**RE: APS Family School East Side  
3303 Monroe St NE  
Drainage Plan and Report  
Engineer's Stamp Date: 2/20/2017 & 12/12/2016  
Hydrology File: G17D019A**

RE: **APS Family School East Side**  
**3303 Monroe St NE**  
**Drainage Plan and Report**  
**Engineer's Stamp Date: 1/30/2017 & 12/12/2016**  
**Hydrology File: G17D019A**

DESERT WILLOW FAMILY  
SCHOOL - PHASE II  
CLASSROOM ADDITION

SHEET TITLE:  
**SITE  
DRAINAGE  
PLAN**

**E5** **WIER SECTION A-A**  
SCALE: 1" = 4'-0" HORIZ.

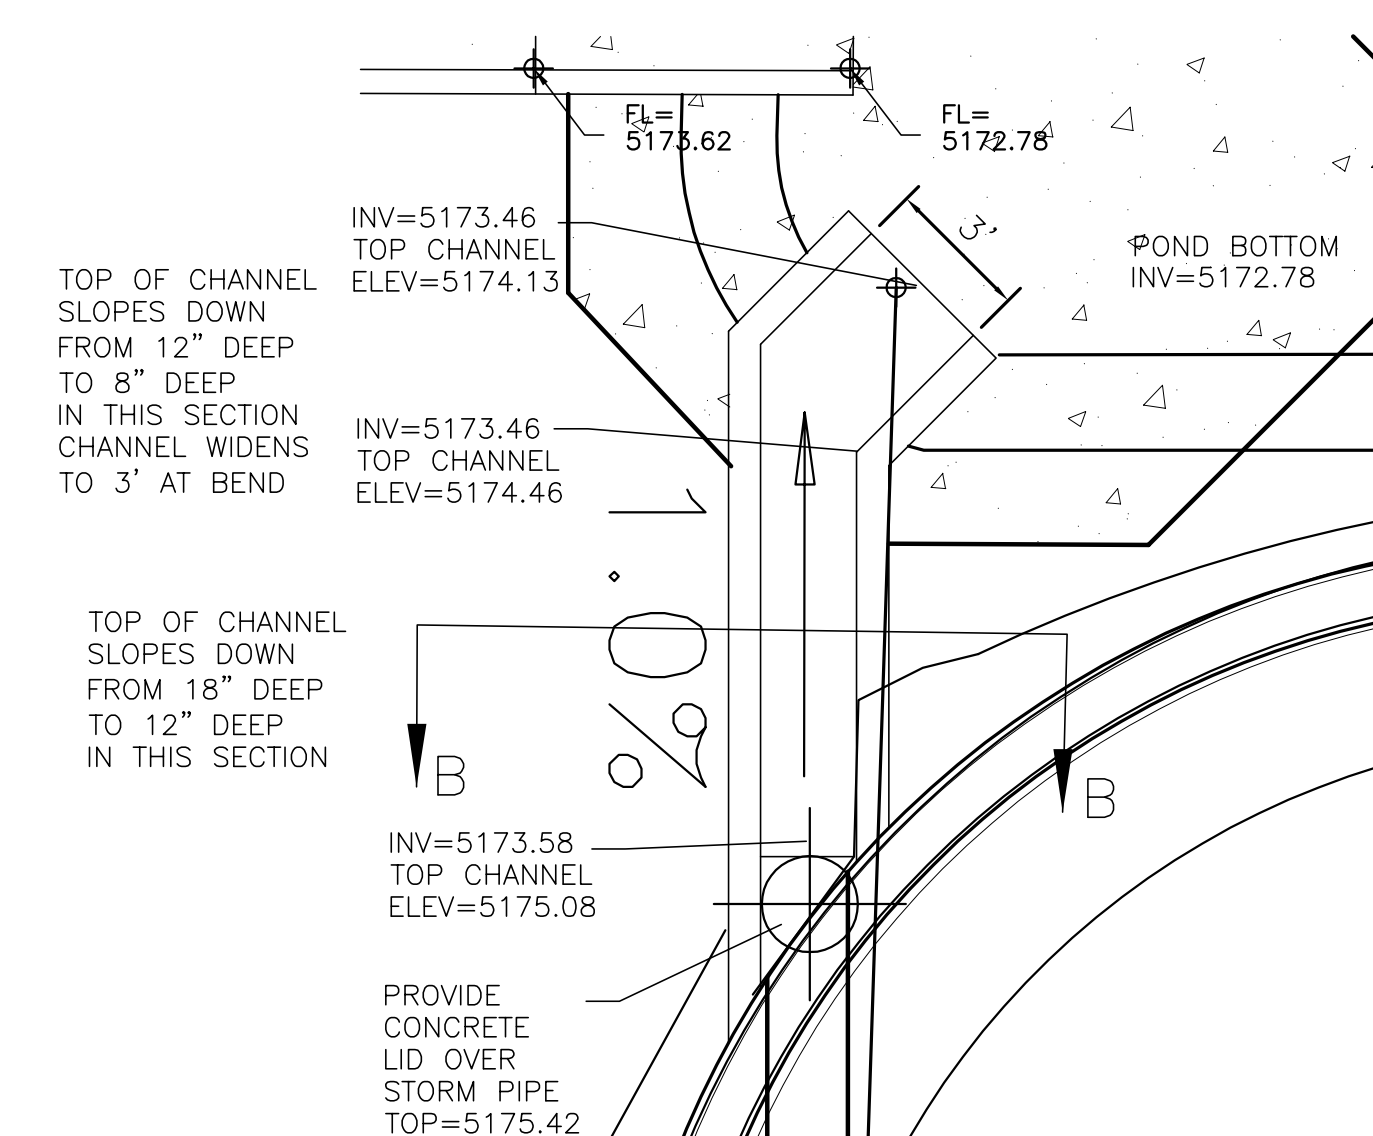
1. Use RVP Class IV underneath the building and the wall
2. Call out Section and detail views for the weir
3. **Correct invert elevation on SD Manhole #2** *(Thank you for noticing).*
